Working Party on Lighting and Light Signalling (GRE)

Proposal for Supplement 9 to the 00 series of amendments to Regulation No. 65 (Special warning lamps)

Submitted by the expert from Germany*

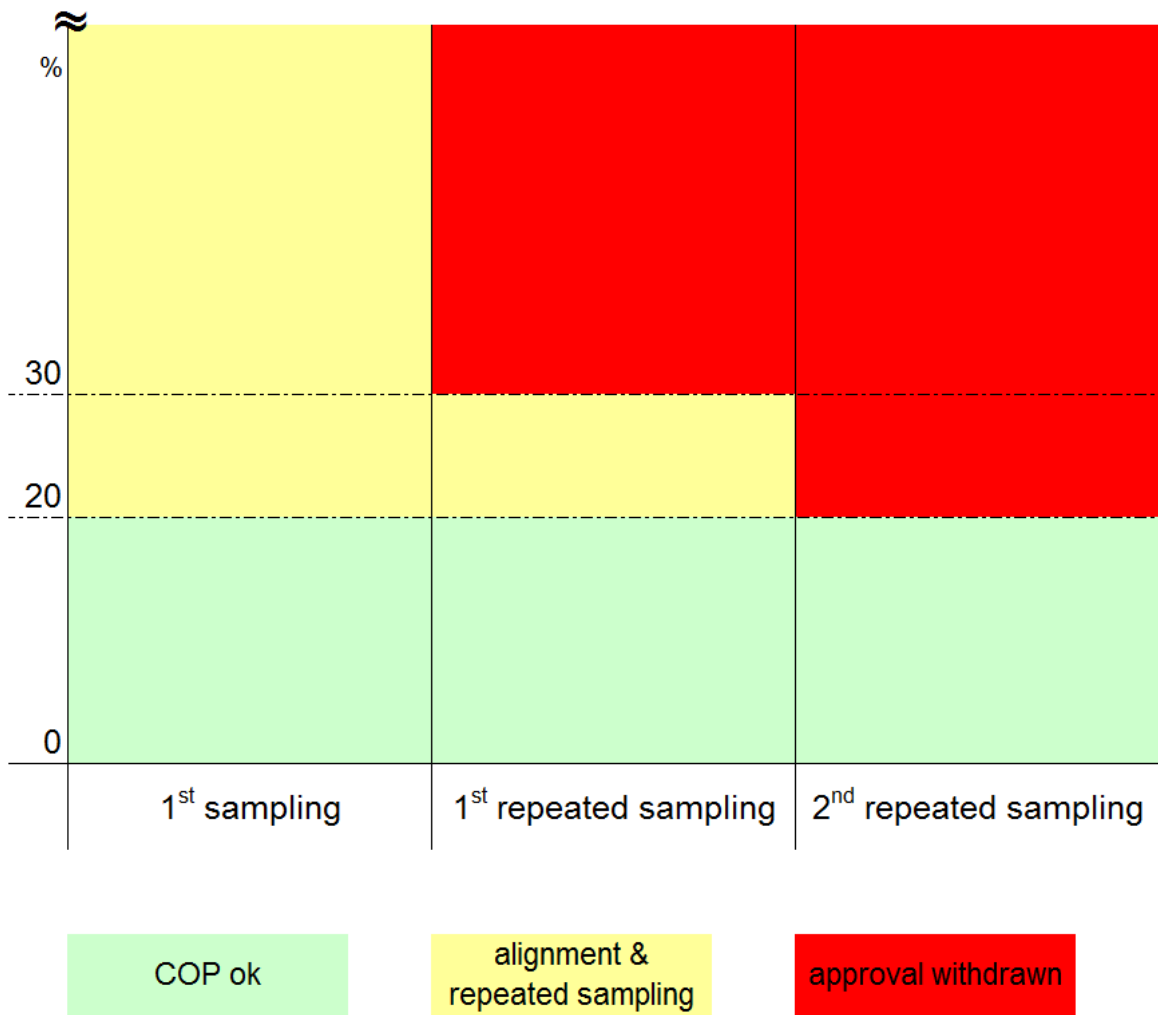
6. CoP is now described in a clear structured stepwise process (with limited steps), which gives the manufacturer the chance in the first step - in the case of deviations of more than 20 per cent - to align his production process. Also, the CoP process can be completed earlier when the first two samples are in the full specifications.

7. The proposal details the "third step" which defines the condition where the approval shall be withdrawn, when after the second repetition of this process the manufacturer was not in the position to "align" his production process in the correct way.

8. The attached drawing shall demonstrate this stepwise process.
